U.S. Nuclear Regulatory Commission
Attention: Document Control Desk
Washington, D.C. 20555-0001Subject: Davis-Besse Nuclear Power Station
Supplemental Information Regarding License Amendment Application to
Support Mark B-HTP Fuel Design for Cycle 15
(License Amendment Request (LAR) 05-0002; TAC No. MC6888)

This letter responds to two NRC requests for additional information (RAI) regarding
LAR 05-0002.

**RESPONSE TO REQUEST FOR ADDITIONAL INFORMATION
DATED JUNE 9, 2005
REGARDING
LICENSE AMENDMENT REQUEST 05-0002
FOR
DAVIS-BESSE NUCLEAR POWER STATION
UNIT NUMBER 1**

**RESPONSE TO REQUEST FOR ADDITIONAL INFORMATION
DATED JUNE 15, 2005
REGARDING
LICENSE AMENDMENT REQUEST 05-0002
FOR
DAVIS-BESSE NUCLEAR POWER STATION
UNIT NUMBER 1**

Figure 2.C-1
RPS Variable Low Reactor Coolant Pressure Trip String

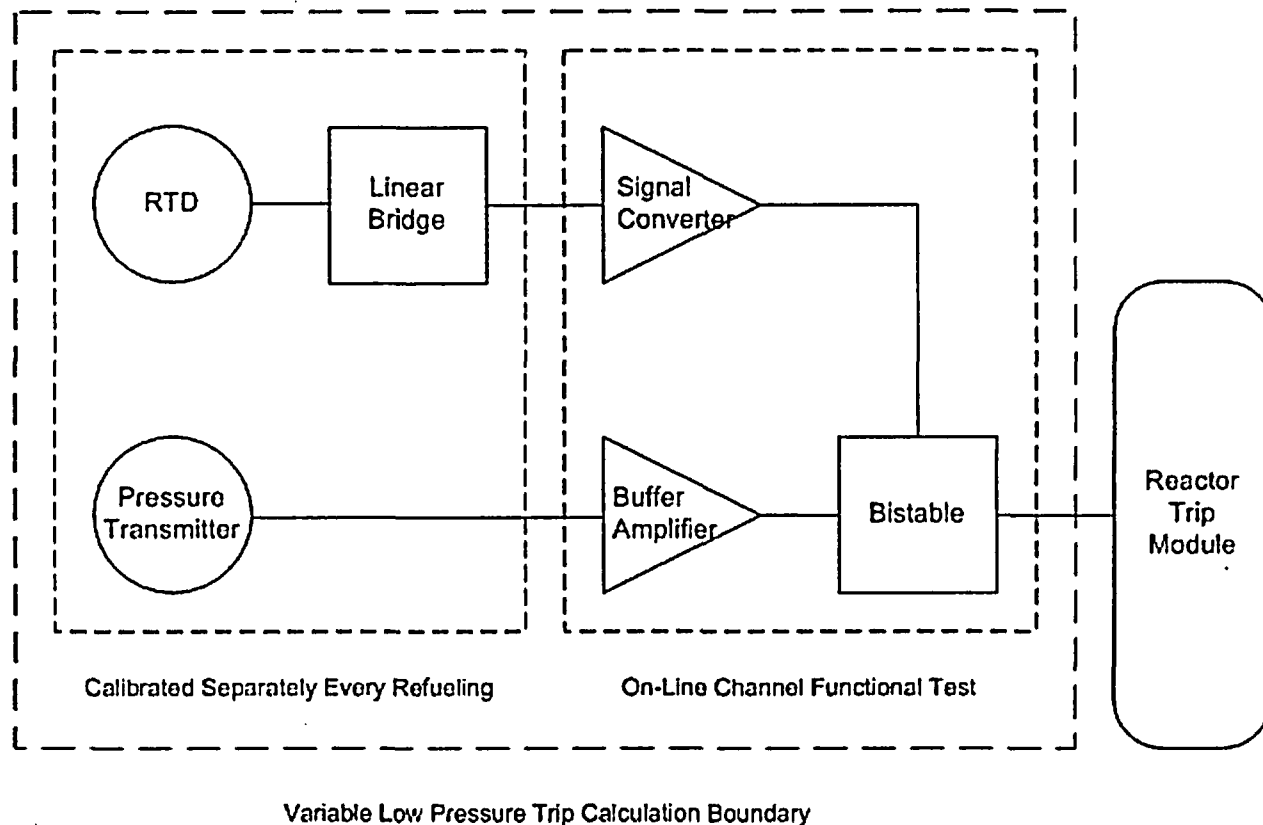
C. Provide a detailed description of the instrumentation uncertainties related to the "RC Pressure-Temperature Trip," and the analyses to derive the RPS "Trip Setpoint" and the "Allowable Value" for this trip function.

RESPONSE 2.C

As described above, a series of core-exit pressure/ core-exit temperature points are calculated for different operating RCP combinations, at the maximum allowed core over-power limit for the pump combination, which results in a minimum DNBR at the TDL for the fuel design being used. The minimum DNBR is calculated using the appropriate NRC-approved CHF correlation. Since the DNBR is a stronger function of temperature, there is a slight "bowing" in the curve with the end-points being more restrictive. The core-exit pressure is adjusted to the hot leg pressure tap by accounting for the dynamic pressure drop and elevation change. This curve represents the Safety Limit on TS Figure 2.1-1.

Since the two end-points are the most restrictive, these points are used to determine the "Allowable Value". By adding the hardware and process measurement errors to these points, the "Allowable Value" can be determined. The component errors are provided by the component vendors. Figure 2.C-1 shows the components included in the instrument string. The random errors for the individual components were statistically combined whereas the non-random errors were combined by linear addition resulting in a total combined error of [] psi. The "Trip Setpoint" is determined by adding the combined uncertainty for setpoint drift, MTE and calibration tolerance (10.72 psi) to the "Allowable Value". (Note that the calculation for the field setpoint for this trip function is being updated. This work is expected to be complete by December 30, 2005.)

The calibration tolerance (10.72 psi) consists of three elements, which were added algebraically: Drift (3.6 psi), measurement and test equipment error (1.12 psi), and additional tolerance (6 psi). Drift was calculated by comparison of as-found vs. as-left data in accordance with Instrument Society of America (ISA) Recommended Practice (RP) 67.04 Part II, Committee Draft 10, August, 1992, *Methodologies for the Determination of Setpoints for Nuclear Safety Related Instrumentation*. [The computation methods in this draft are equivalent to those described in the 1994 revision of the RP.] It should be noted that the as-found/as-left data may include the combined effects of reference accuracy, inherent drift, measurement and test equipment, humidity, vibration, normal radiation, normal temperature, and power supply variations during the time period of the surveillance. A value for drift obtained by this methodology is conservative as it will include some or all of these other uncertainties and the allowance that is determined will bound 95% of future observations with a 95% confidence.
